**Quantum™**

**Subject: Proposal for Ultra320 AAF receiver input signal specification for SPI-4**

Figure 1 – Fast-160 AAF receiver mask showing VCLKPP on a free-running clock with a settled 1010 pattern

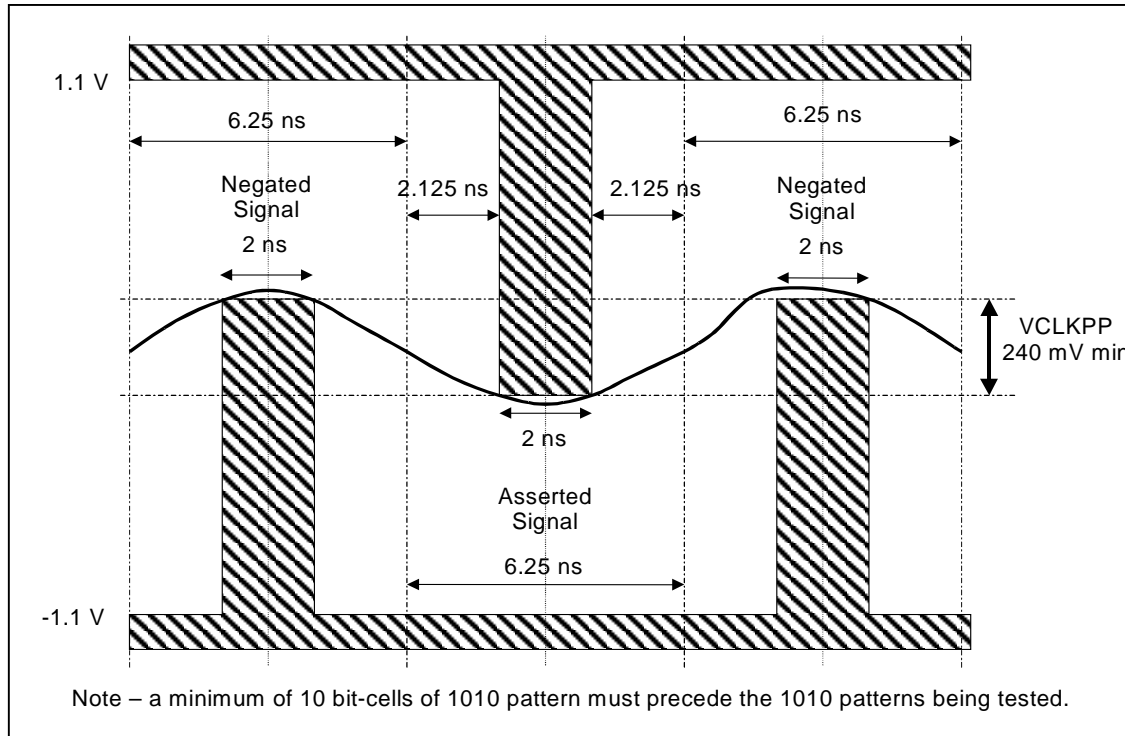
The free-running clock and settled 1010 data pattern amplitude, VCLKPP, is defined as the sum of the minimum negated and asserted amplitudes, each measured within a 2 ns interval centered on the appropriate bit-cell centers as shown in Figure 1. The bit-cell boundaries are defined as the average zero crossings of a settled 1010 pattern. The bit-cell center is the mid-point between bit-cell boundaries. The measured data waveform shall be band-limited to 200 MHz.

$$VCLKPP > 240 \text{ mV}$$

Figure 2 – Fast-160 AAF receiver mask showing minimum amplitude change for all signals

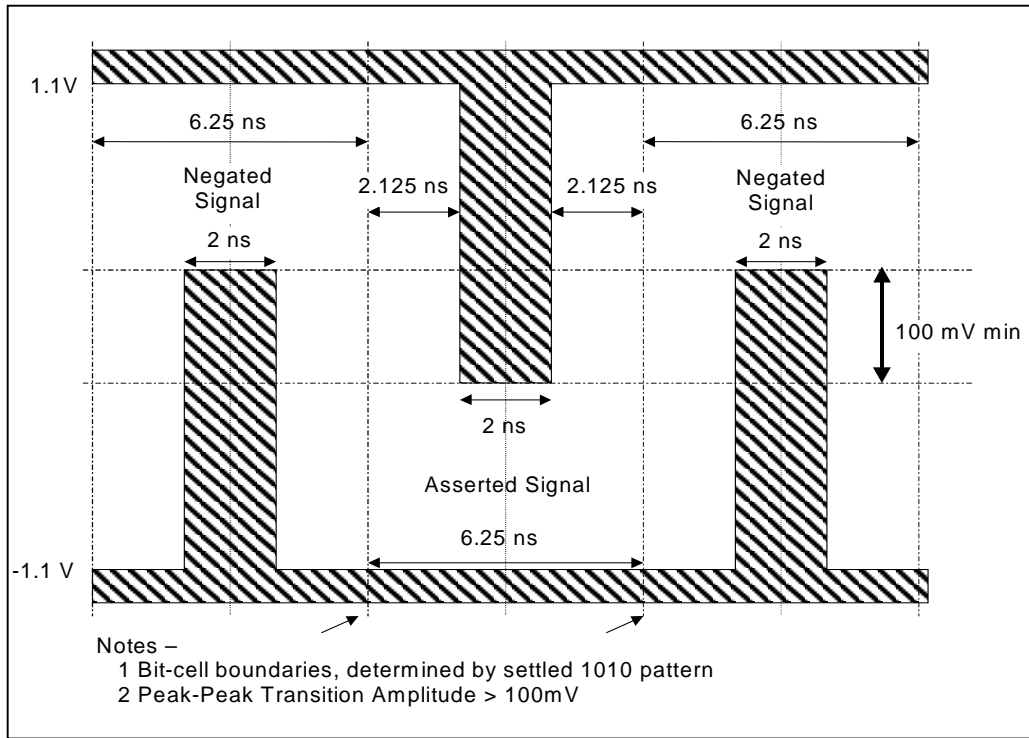
The amplitude change at all transitions shall exceed 100 mV measured as shown Figure 2. The measured data waveform shall be band-limited to 200 MHz.

Figure 3 – Fast-160 receiver mask eye diagram, offset removed

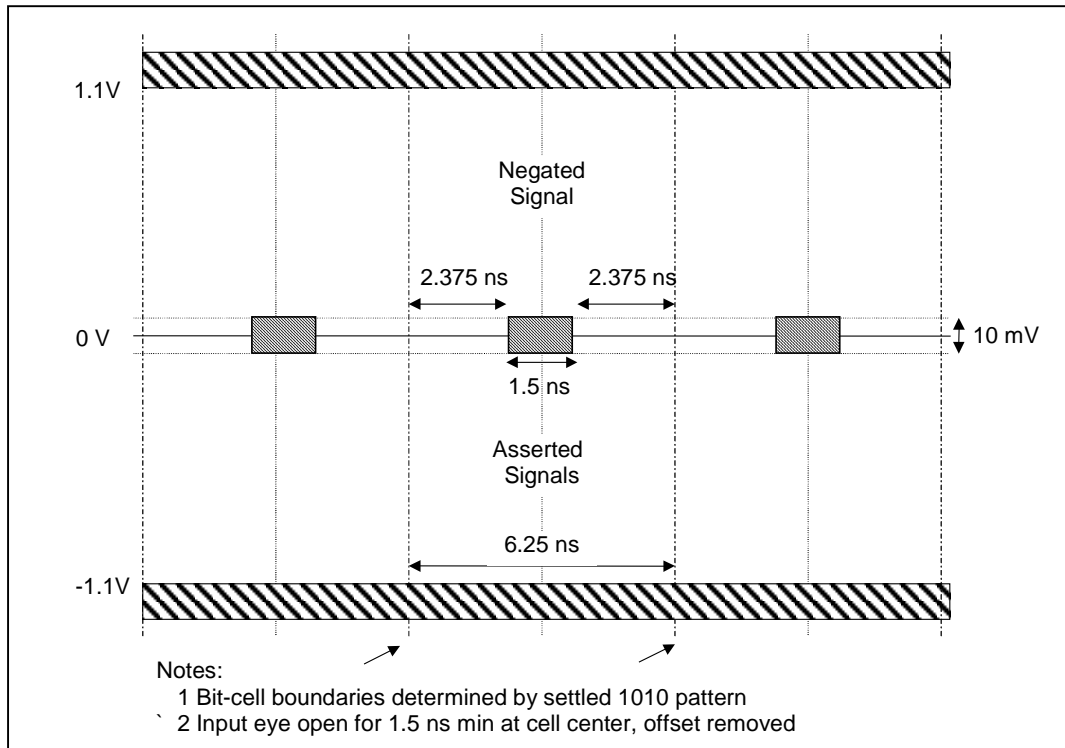
- a) Eye diagram mask: The eye diagram formed by superimposing the waveforms of all bit cells of the input data pattern shall be open for 1.5 ns centered on bit-cell center as shown in Figure 3, where bit-cell center is determined by the location of a settled 1010 clock pattern in the input waveform.
- b) All-transitions x-0-x (don't care – negation – don't care) and x-1-x (don't care – assertion – don't care) masks: Figure 4 and Figure 5, when combined, form the traditional eye mask shown in Figure 3 with limits that permit the eye to be nearly closed. For a negated signal, the receiver input waveform shall exceed 5 mV for 1.5 ns centered on the bit-cell center as defined by the free-running clock pattern (see Figure 4). For an asserted signal, the receiver input waveform shall remain less than -5 mV for 1.5 ns centered on the bit-cell center (see Figure 5).
